651S-1
GENERAL PURPOSE HF RECEIVER

PUB NO.	NOTE	DATE	SUBJECT
IB 1-72 ✓		03/01/72	Subassembly Interchangeability
SB 1		10/01/72	Reduction of 450-kHz Leakage From Synthesizer Reference Board All
SB 2		06/06/73	Reduction of Noise Level
SB 3		07/15/73	Add Keep-Alive Frequency Memory Function
SB 4		07/15/73	Extend Comma and Decimal Lamp Life in Frequency Display
SB A ✓		11/01/73	Change DCFE Filter Switching Diode
SB 5	1	12/15/74	Minimize TCU Circuit Card Response to Data Link Noise and Failure
SB 6	2	03/01/75	Reduce Intermodulation Level
SB 7		02/07/75	Reduce Internal Spurious Signals
SB 8		12/27/74	Allow Remote Control Operation With RS-232C Serial Control Interface Card A9
SB 9 ✓		02/15/75	Increase Life of Display Tubes
SB 10 ✓	2	12/31/75 Revised 08/02/76, 04/01/77	Replacing Display Tubes With LED Plug-in Assemblies
SB 11		Not issued	
SB B ✓		11/15/74	KAV
SB C ✓		01/15/78	Supply KAV Power to DCFE
SB 12 ✓		05/01/78 Revised 07/01/78	Replacing Nonprocurable Integrated Circuits

SERVICE BULLETIN A

SUBJECT: Change DCFE Filter Switching Diode

*Order if needed.

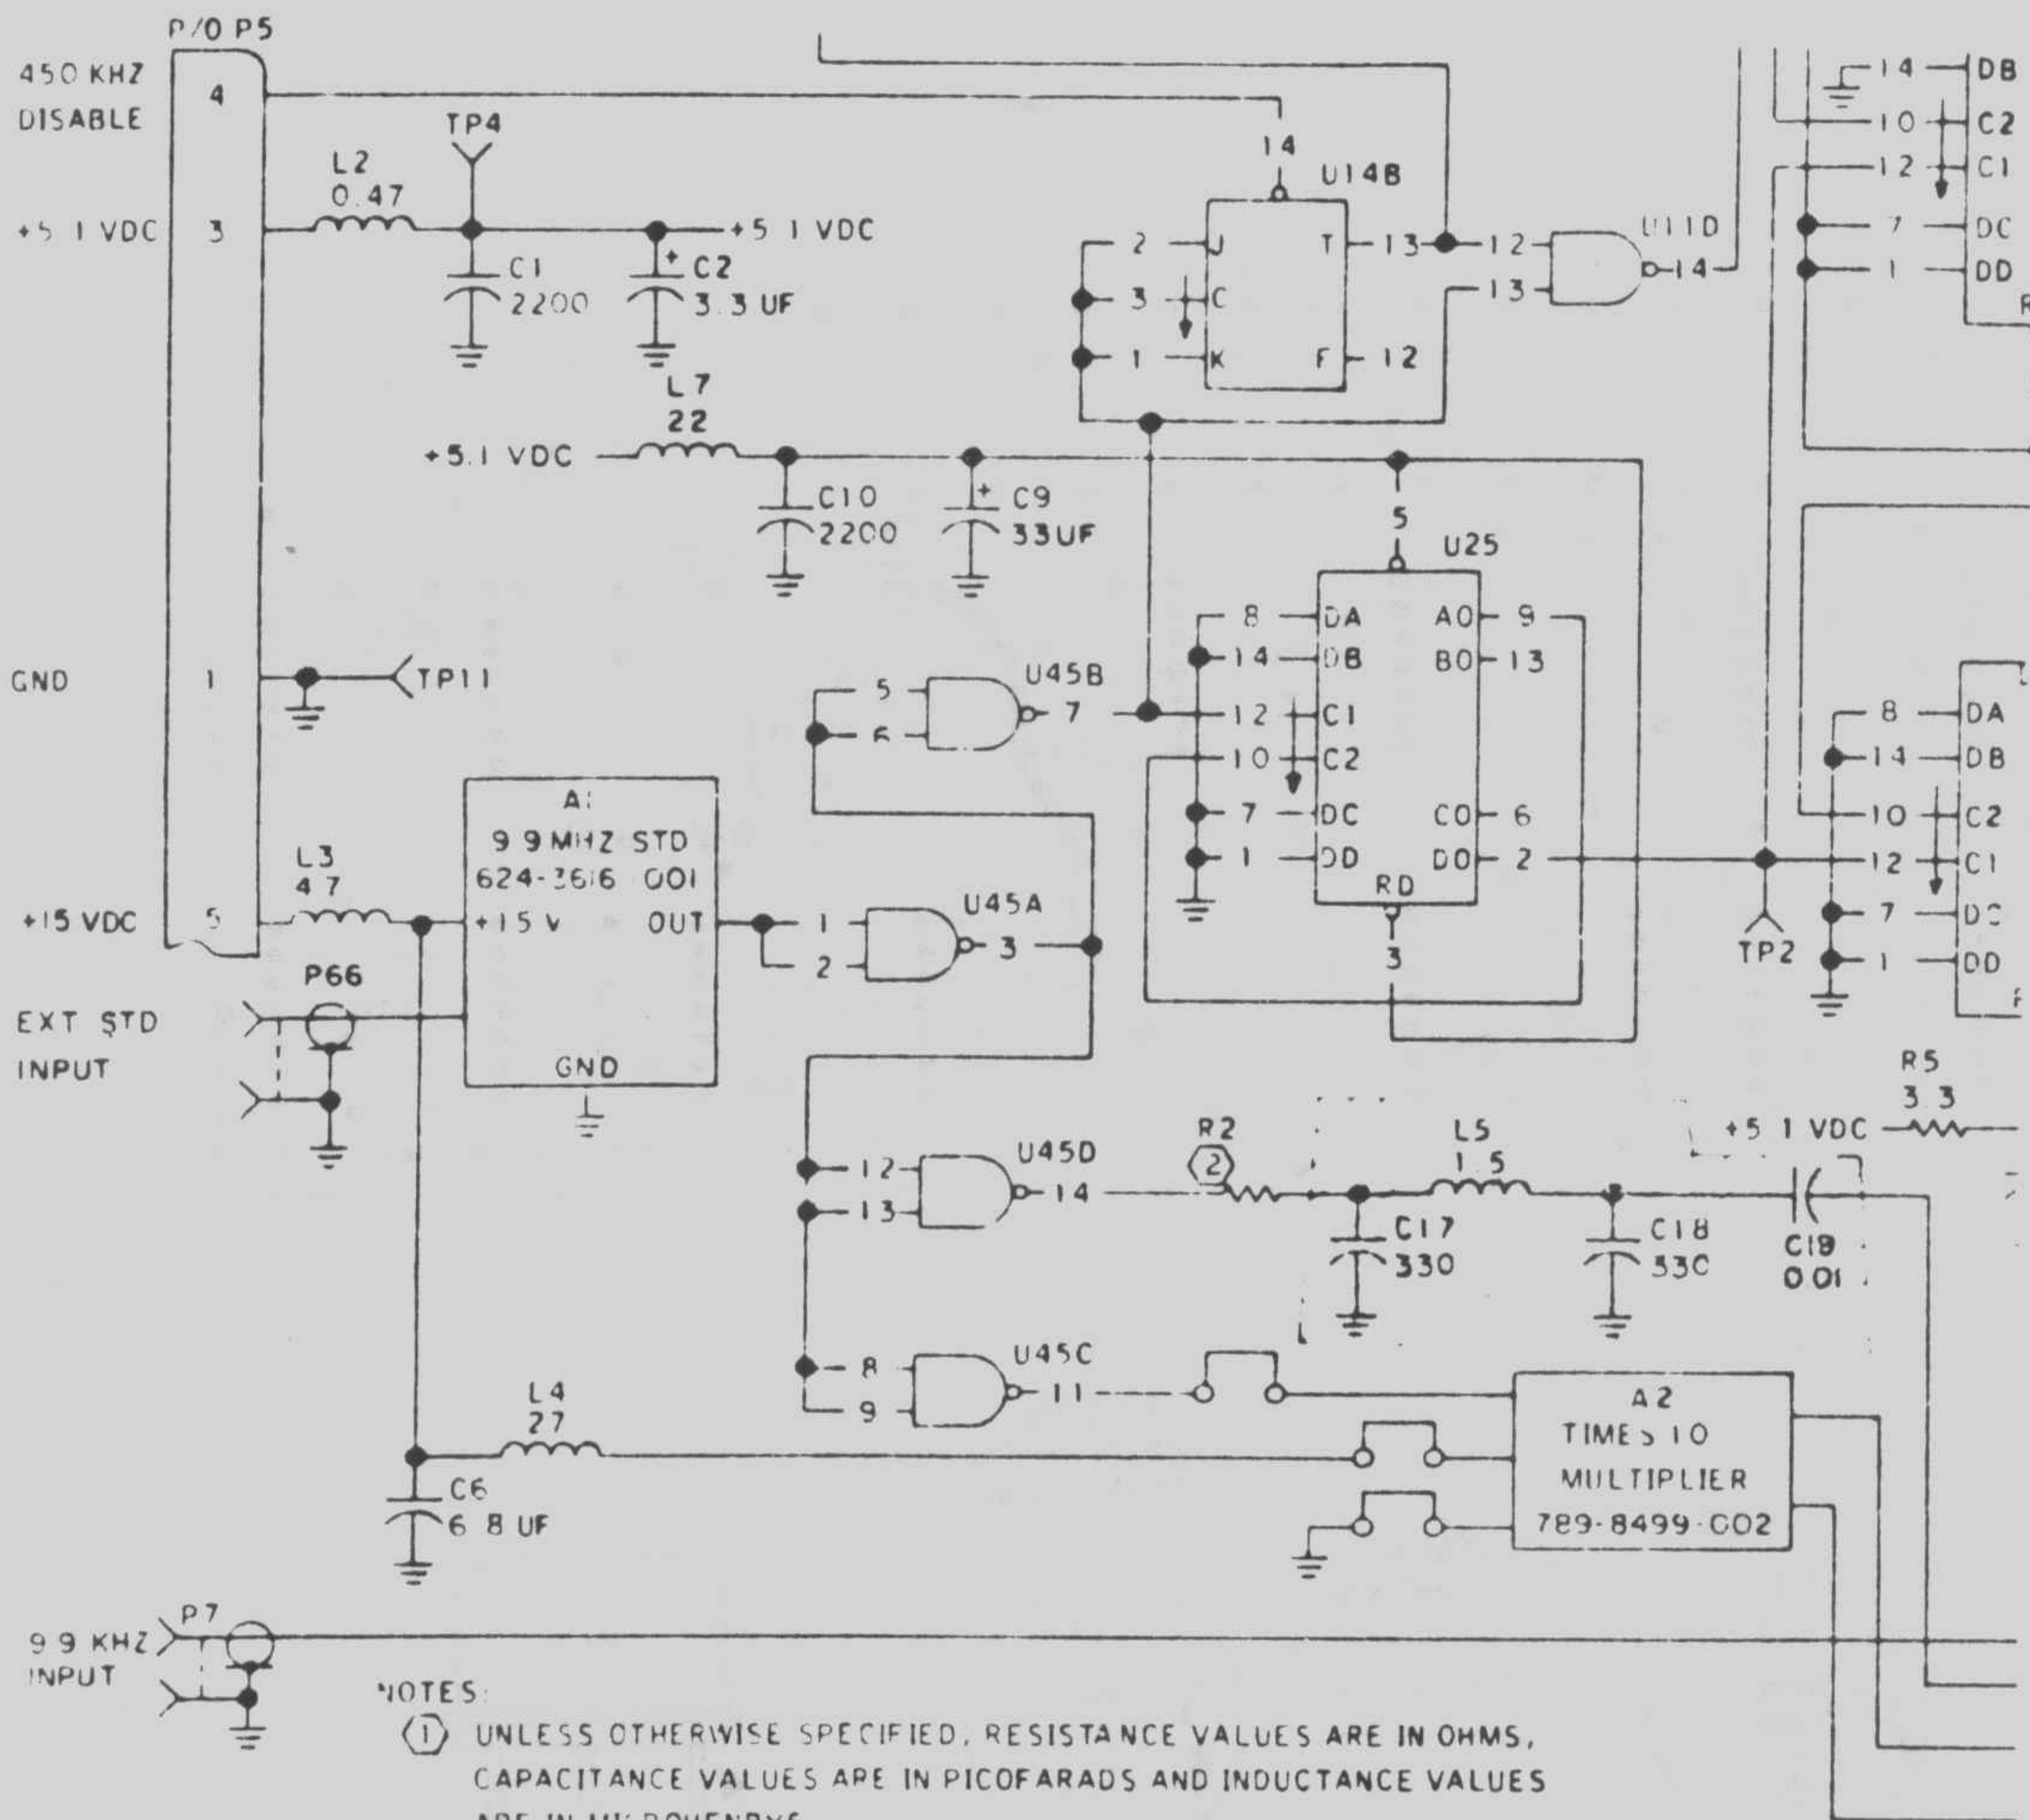
NOTE: Refer to figure 1 of this bulletin while performing steps F through I. Refer to figure 2 for before and after modification schematic diagrams.

- F. Unsolder and move the square pin and coax cable shield from hole 1055 to hole 258. Solder the pin in hole 258.
- G. Install 9.9-MHz crystal Y1 (289-7140-010) with insulator (352-9552-550) into holes 453, 454, and 1055 on top of board as shown in figure 1.

P/O DCFE Circuit Card Assembly A8 (624-5744-001)
Figure 1

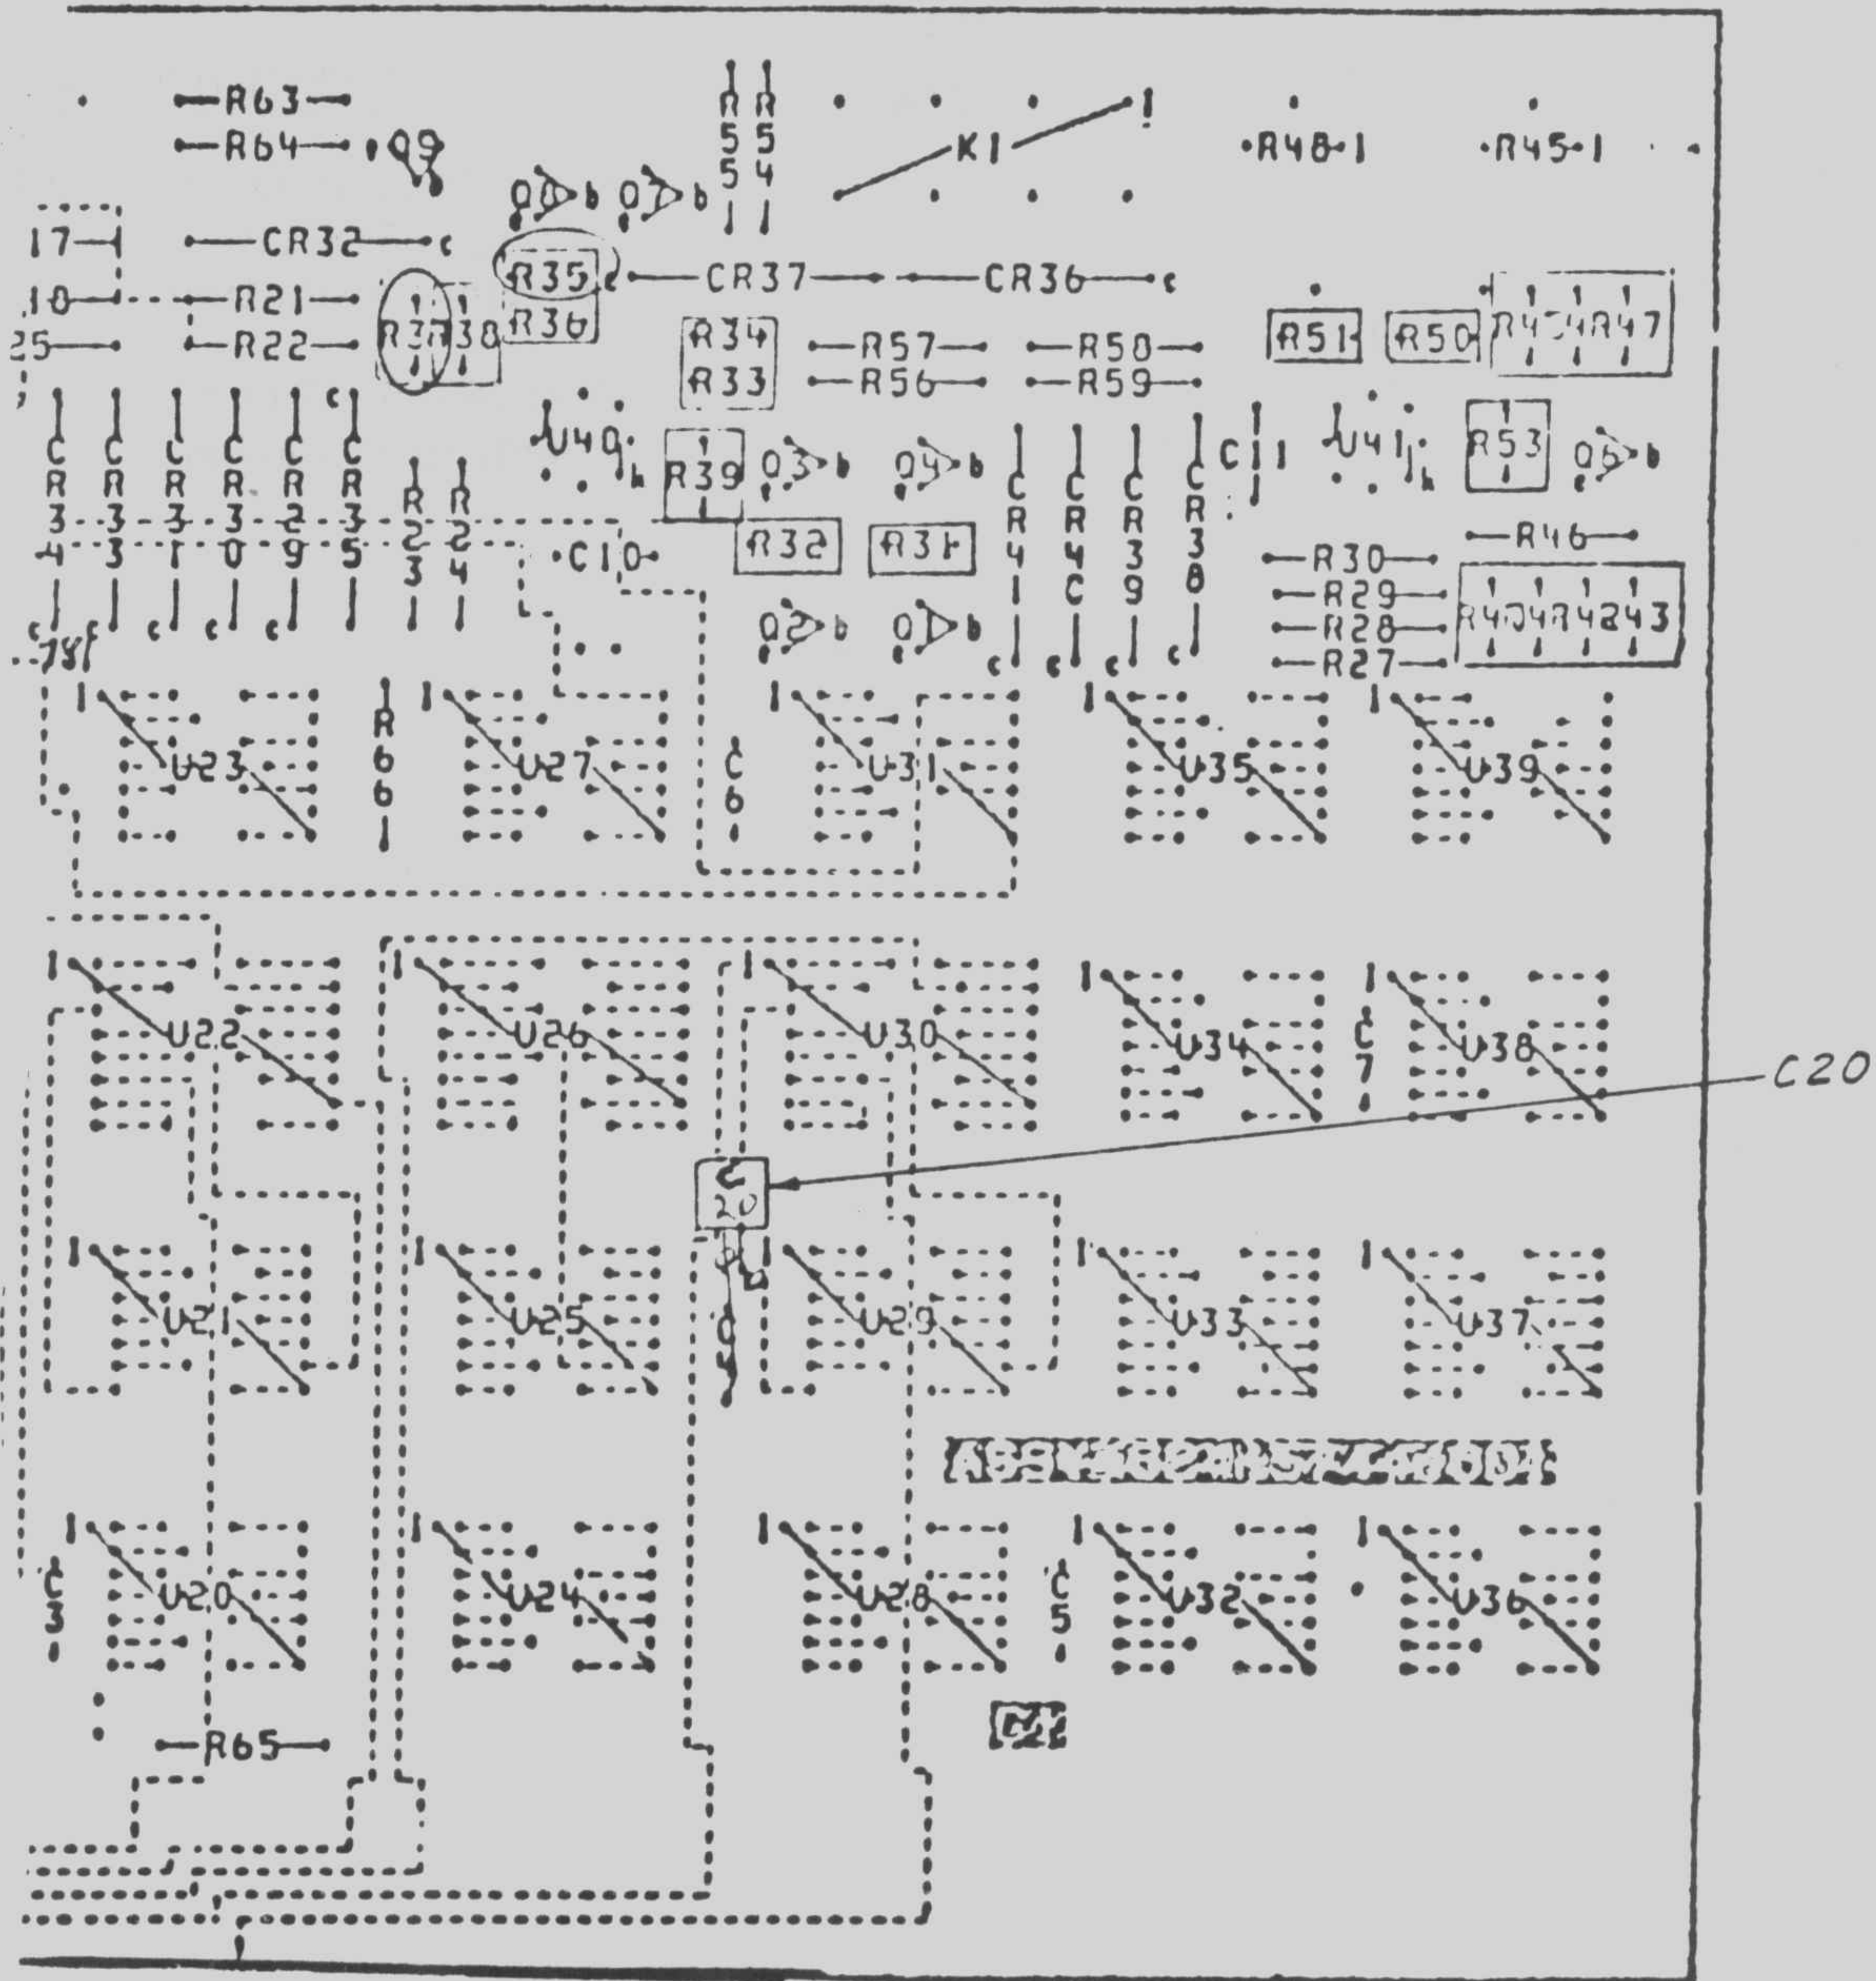
- E. Install a 1500-pF capacitor C20 (913-3279-040) between U29-3 and C4 bottom lead as shown in figure 1. Use sleeving (152-2463-000) on the capacitor leads.
